RE: NPDES Permit #NV0023060 – Amendment to Renewal Application
Nevada Environmental Response Trust Site
Henderson, Nevada

As requested by the Nevada Division of Environmental Protection, Bureau of Water Pollution Control (NDEP – BWPC) in your recent conversation with Mr. Andrew Steinberg of the Nevada Environmental Response Trust (NERT or the “Trust”), please find enclosed information related to the changes to the NPDES permit renewal application for the Henderson, Nevada site. The NPDES permit renewal application was submitted to NDEP – BWPC on January 6, 2016 (the “Renewal”). As Mr. Steinberg indicated, NERT has been requested by NDEP – Bureau of Industrial Site Cleanup (NDEP – BISC) to modify the Renewal to include provisions for the potential treatment of impacted groundwater removed during the dewatering activities associated with the construction of two weirs by the Southern Nevada Water Authority (SNWA) along the Las Vegas Wash. In order to treat the groundwater extracted during dewatering activities, NERT will have to increase our capacity to treat contaminated groundwater. Based on an initial analysis, the NERT believes ion exchange (IX) to be the best treatment option, w

Figure 1: Layout Map with Proposed SNWA Weirs and Three Proposed IX Treatment Systems at Lift Station 1

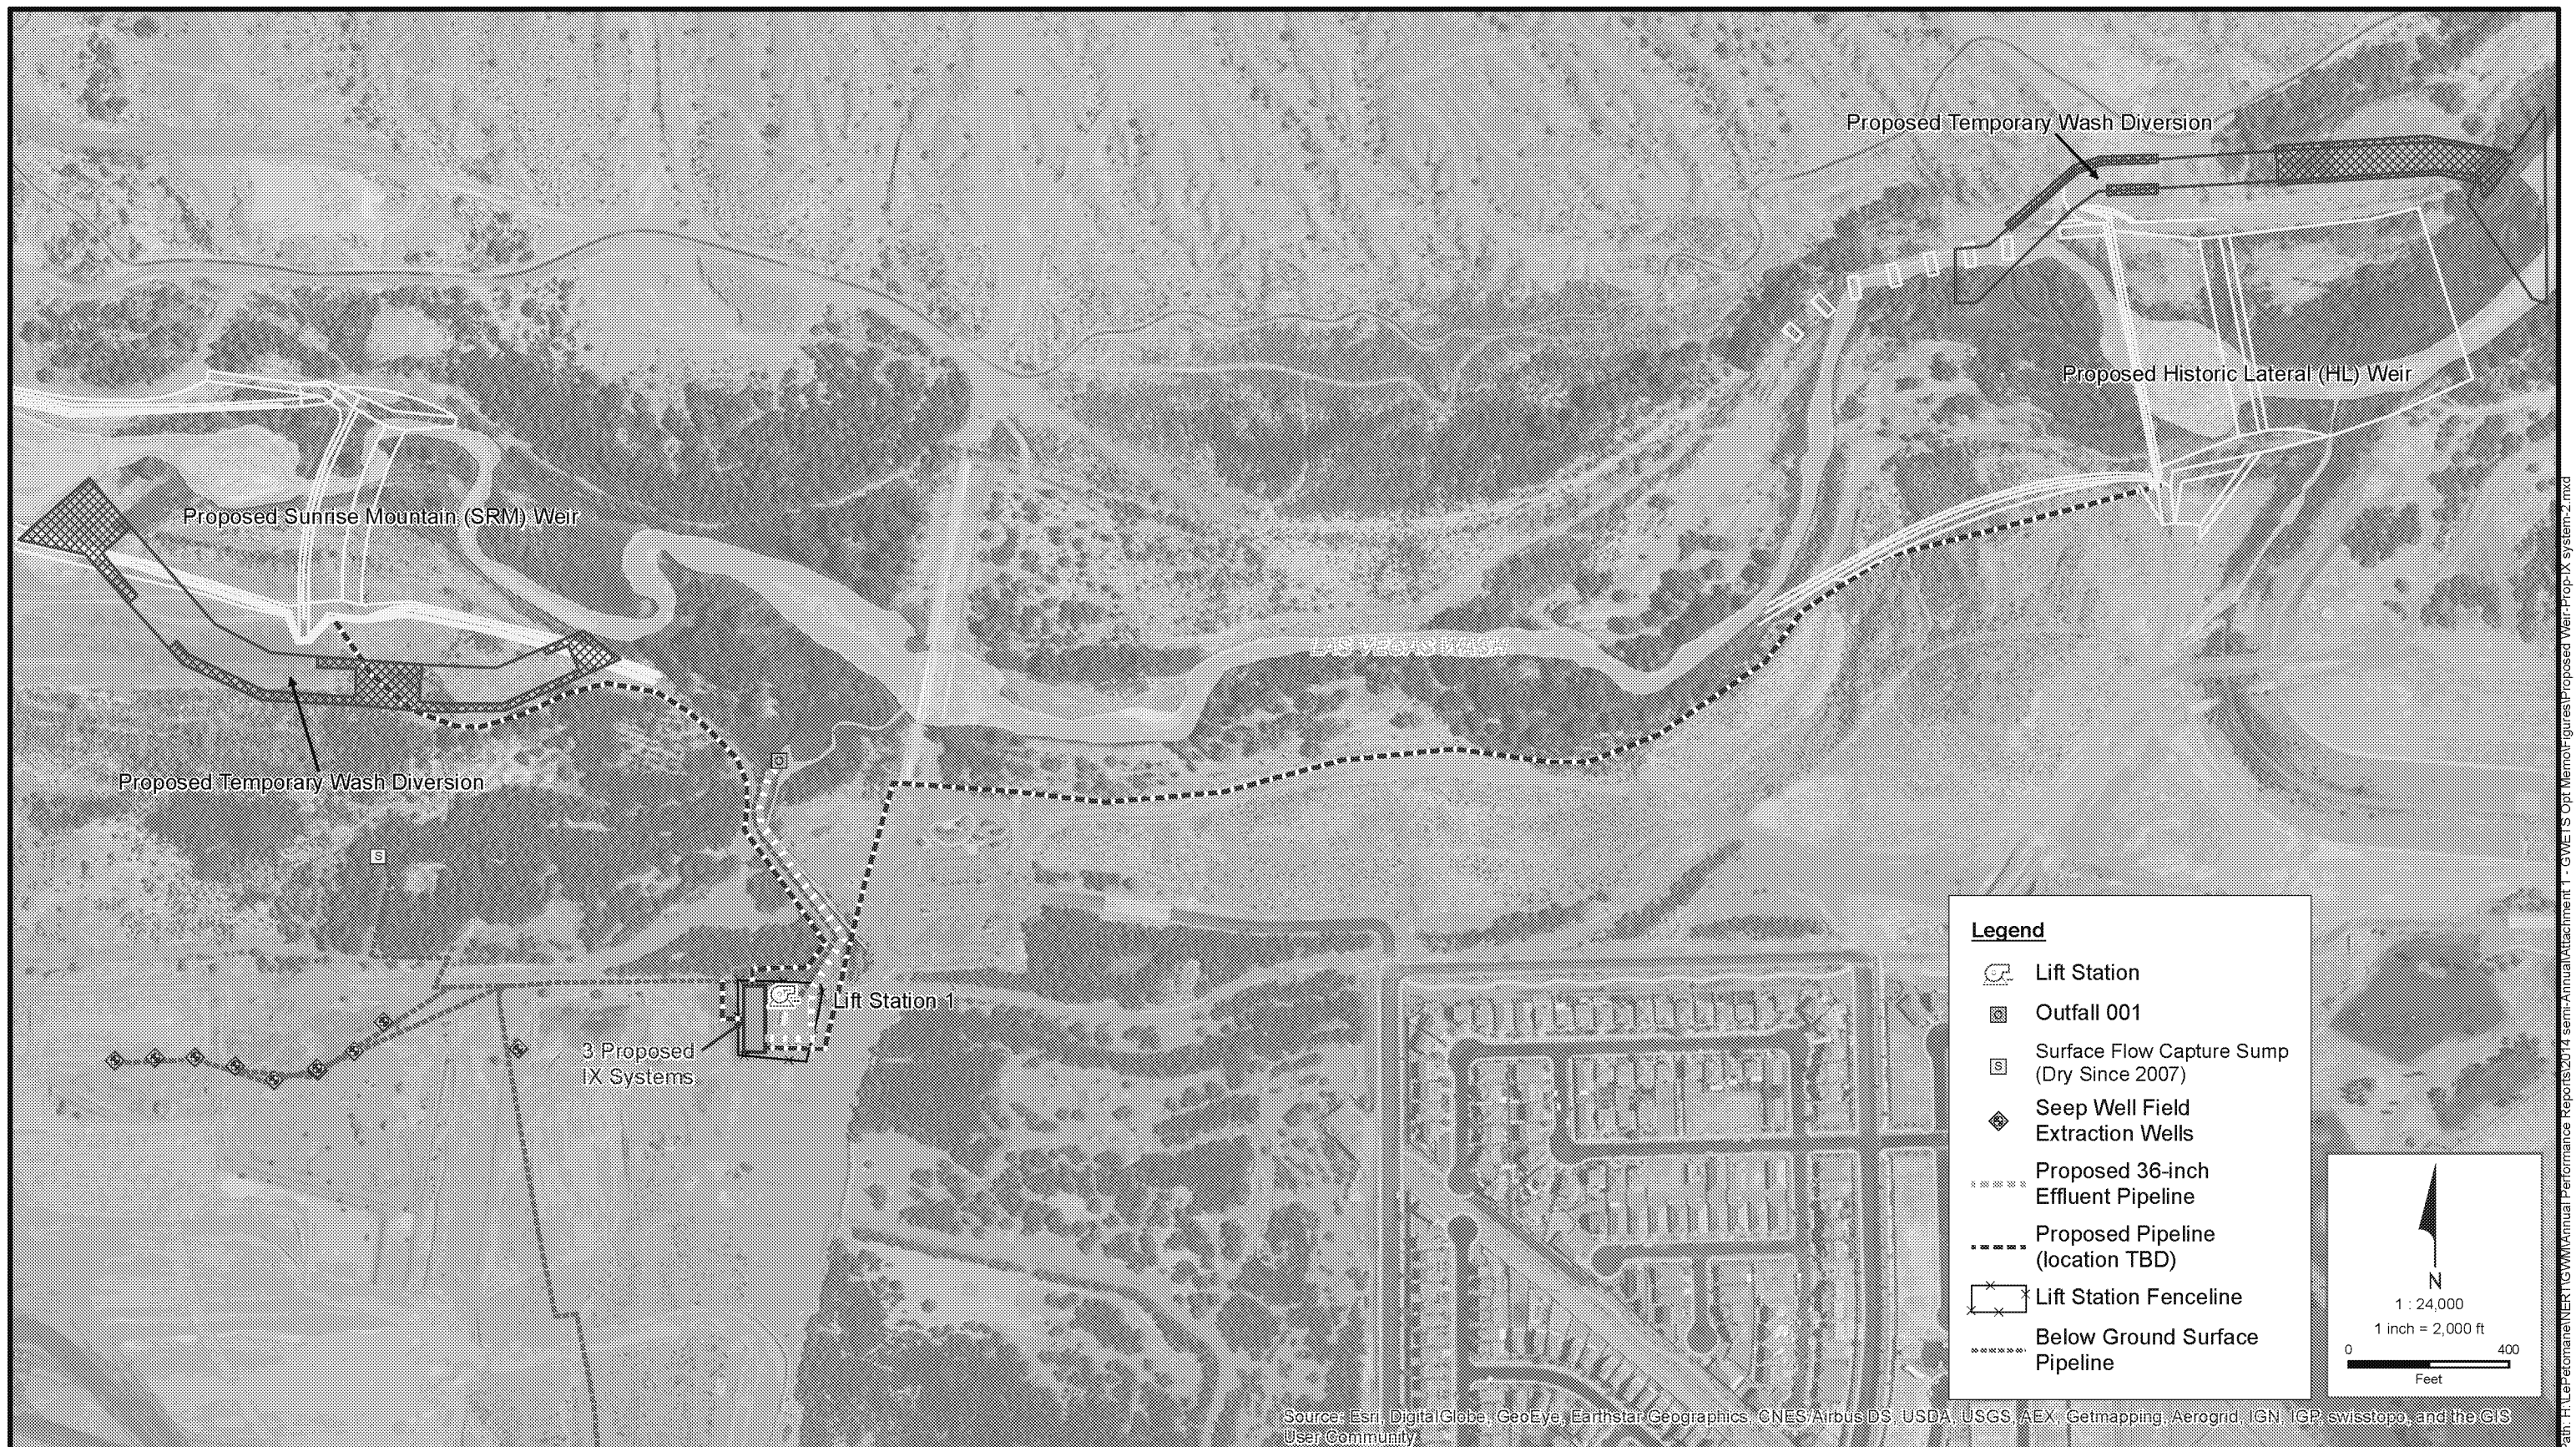
- Construction two additional ion exchange (IX) treatment systems. These systems are proposed to be constructed adjacent to the proposed IX treatment system at Lift Station 1 that was identified in NERT’s permit renewal application dated January 6, 2016. The total discharge capacity of the expanded IX treatment systems will be 3,300 gallons per minute (gpm). The groundwater chemistry at the weir construction sites is believed to be very similar to the groundwater extracted by the existing Seep Well Field (SWF). As such, NERT anticipates that the additional IX treatment systems will be sufficient for treating the groundwater prior to discharge at NERT’s existing outfall.

- Replacement of approximately 700 feet of the existing effluent pipeline to handle an increase in effluent discharge. NERT anticipates that the existing effluent pipeline between Lift Station 1 and Outfall 001 will be replaced with a 36-inch diameter effluent pipeline to accommodate discharge from the on-site fluidized bed reactor (FBR) biological treatment plant and the effluent from the expanded IX treatment systems. NERT anticipates that this pipe will be equipped with an effluent metering station.

Figure 1 displays the layout of the planned weir construction sites, the proposed IX treatment systems at Lift Station 1, the existing seep well field (SWF) extraction wells, and the associated existing and proposed pipelines.

Figure 2: GWETS Flow Diagram with Three Proposed IX Treatment Systems and Proposed AP-5 Pond Closure Project Flows

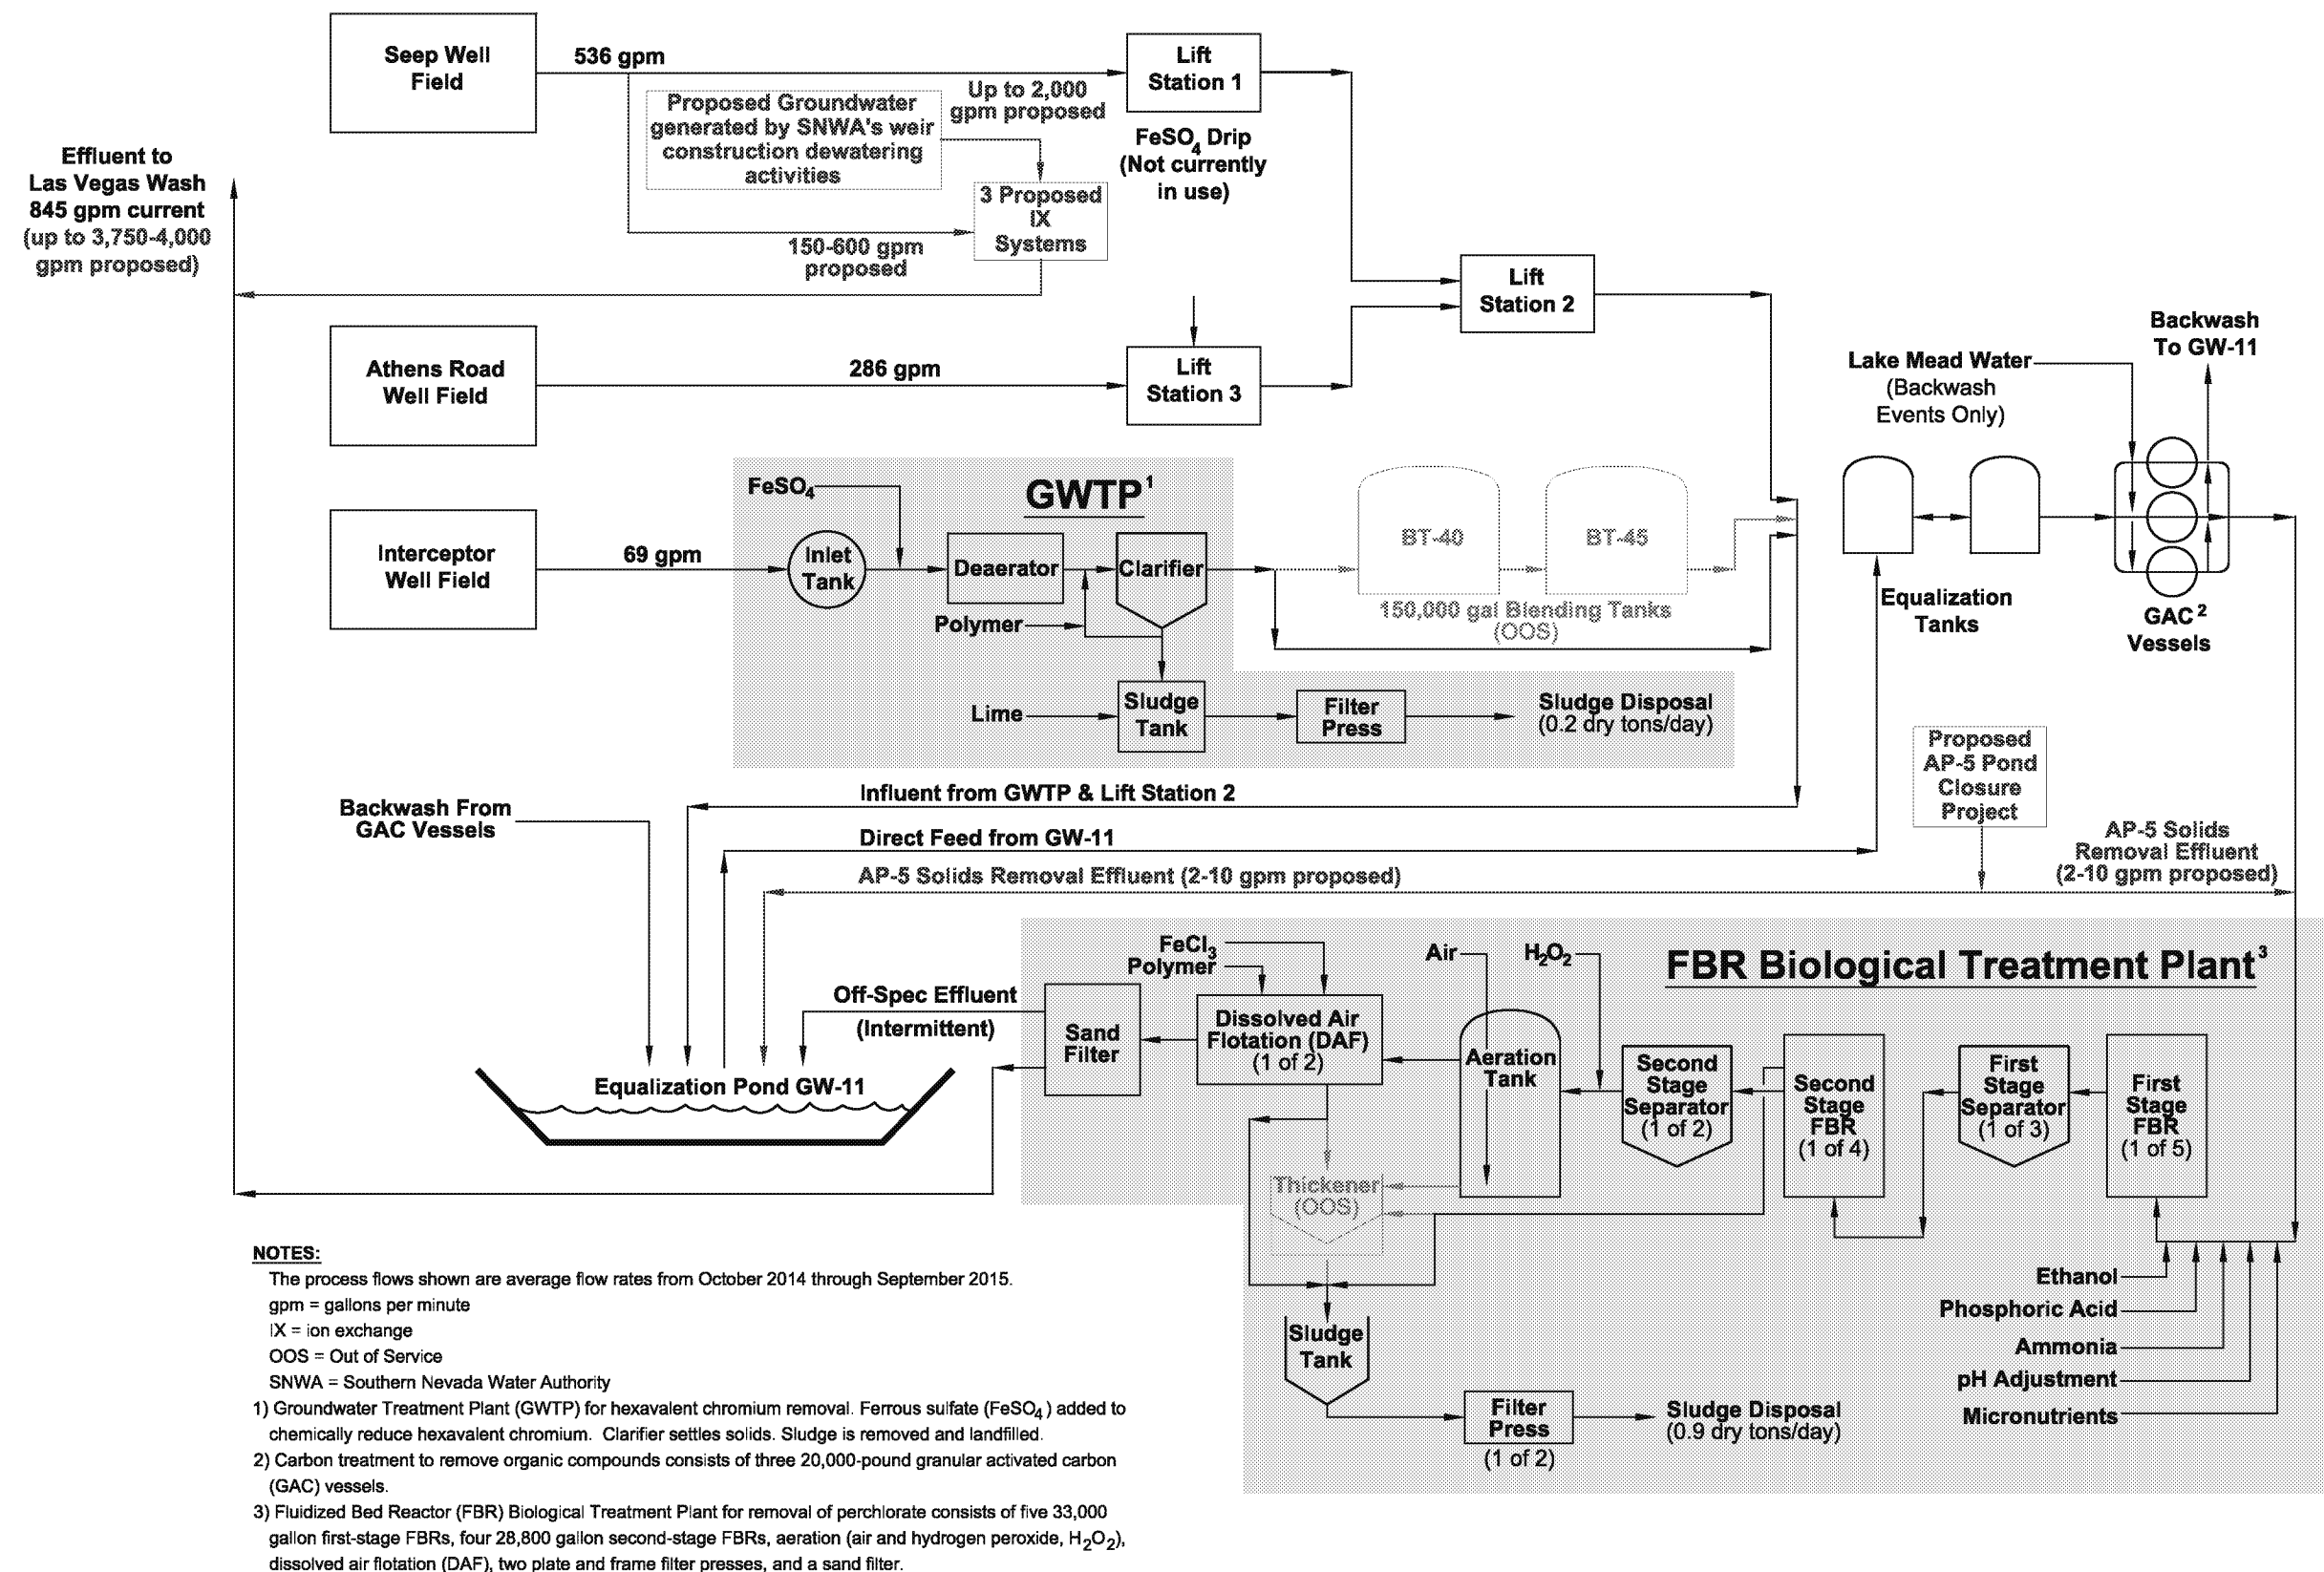
Figure 2 show a modified flow diagram for the entire groundwater extraction and treatment system (GWETS) that includes the proposed IX treatment system flows and the proposed AP-5 pond closure project flows. A modified process flow diagram for the proposed IX treatment systems at Lift Station 1 is provided in Drawings 1373-134-P001 and 1373-134-P002 (Attachment 1). Table 1 displays the discharge rates of NERT's biological and IX treatment systems. As indicated in Table 1, NERT is seeking a 30-day average effluent flow rate of 3,750 gpm and a daily maximum effluent flow rate of 4,000 gpm).
